Lahontan Regional Water Quality Control Board

Response to Water Board Advisory Team's August 13, 2020 Request for Information Regarding the Proposed Cleanup and Abatement Order for Ramiro Villa Avila, Los Angeles County Assessor Parcel No. 3030-020-043

Figure 1: Satellite image showing Site greenhouses, annotated with ephemeral drainages, soil stockpiles, and greenhouse perimeters.

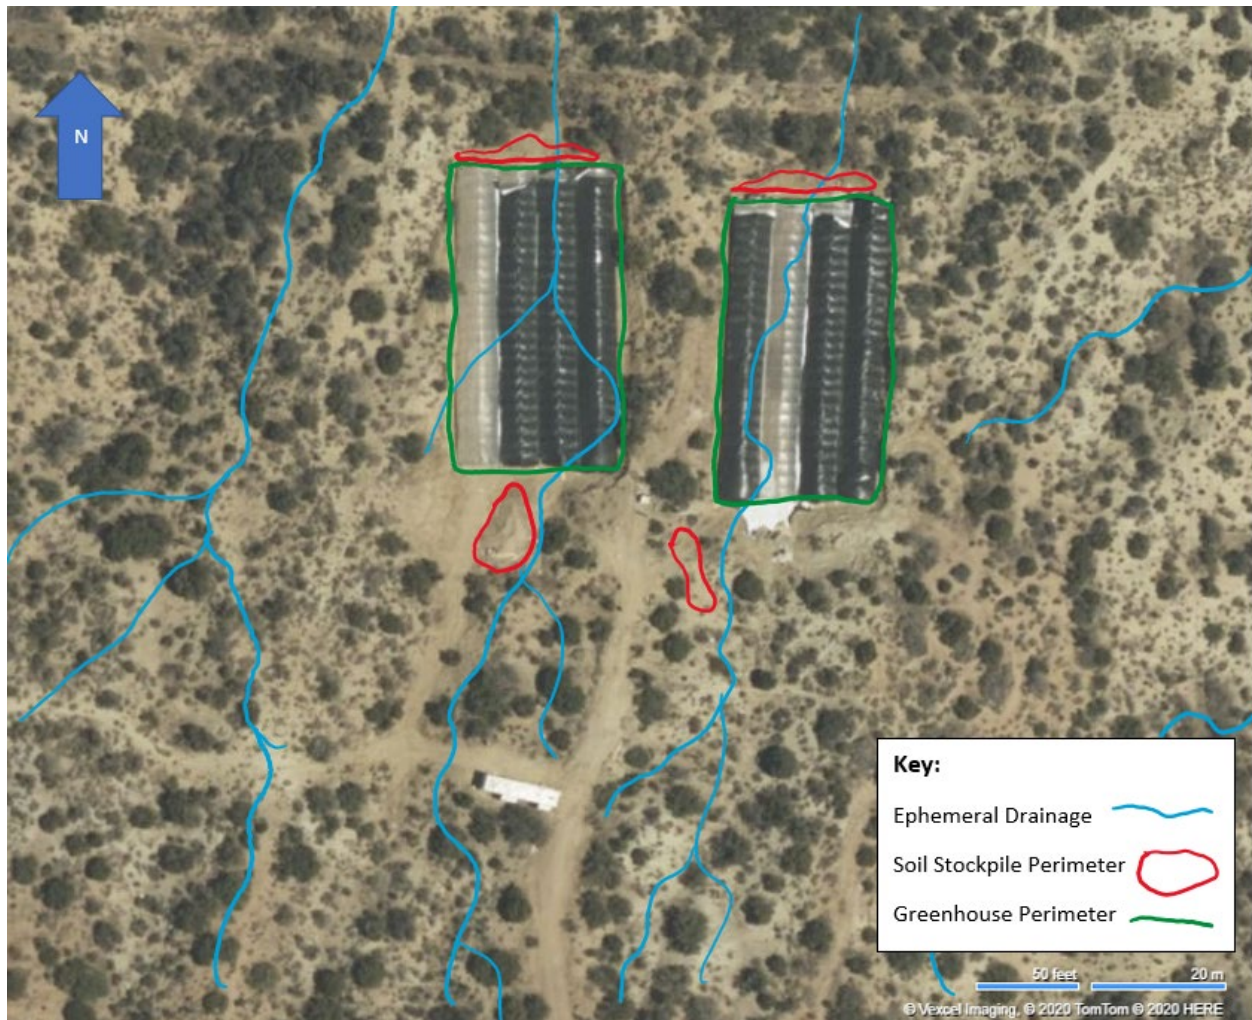
4. The Order does not include a description of the drainage channels. Please provide a scaled site map of the drainage channels showing the areal extent of alleged disturbance, or some other picture or description depicting this information.

Response: Scaled images with directional arrows and Site features are provided in Figures 1 and 2, below. Additional detailed information is provided in Attachment 2 of the proposed CAO, which is an inspection brief containing photos, satellite imagery of the drainages with Feature Identification (FID) numbers denoting important locations, and narrative descriptions associated with the FID numbers that include distances and areas within the filled drainage channels.
